# Impact of Removal of Housing on Structural Analysis of DN30 Package

0023-PRT-2024-014 Rev. 0

# Valve Margins with/without Housing

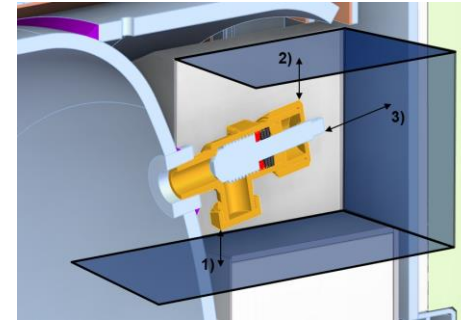
- **Measured vertical and longitudinal distances between valve and VPD are shown on the right**
  - **As proven by results on next slide...**
  - taking into account corrected valve dimensions only has an impact on distances 2) and 3)
  - margins for distance 3) are very large though so that no issue arises in this regard
  - corrected valve dimensions reduce margins for distance 2) by ~12 mm, especially important for SQ8 (flat drop onto top of DN30 PSP)
  - taking into account impact of detailed cavity shape further reduces margins for distance 2) [as well as distance 1)]
  - combining all penalizing assumptions regarding temperature, package mass, and manufacturing tolerances at the same time consumes the remaining margins
- **Removal of housing would drastically reduce any risk of contact between the valve and any other part of the DN30 package**

a) Impact of incorrect DN30 PSP cavity is estimated to reduce the distance between valve and housing by 8 mm, which corresponds to increase of cavity for top/bottom half of DN30 PSP

b) Not an actual restriction because this distance is only affected by deformation of cylinder skirt

- Distances correspond to minimal values during whole simulation time
- Since gravity is not modelled explicitly, decelerating the upwards movement of the 30B cylinder, unrealistically small distances can result opposite to drop direction (highlighted in gray for sequence 5 and 8)

- **Housing has no function with regard to structural safety of DN30 package**
- **In fact, any risk of contact between valve and any other part of the package is decreased by removing the housing**
- **Removal of housing from the DN30 package design does not affect any of the performed simulations and no new simulations are required**
- **Solely to the documentation of the structural analysis small changes are necessary to remove the housing from the design**
- **Removal of housing only increases the structural safety of the DN30 package**
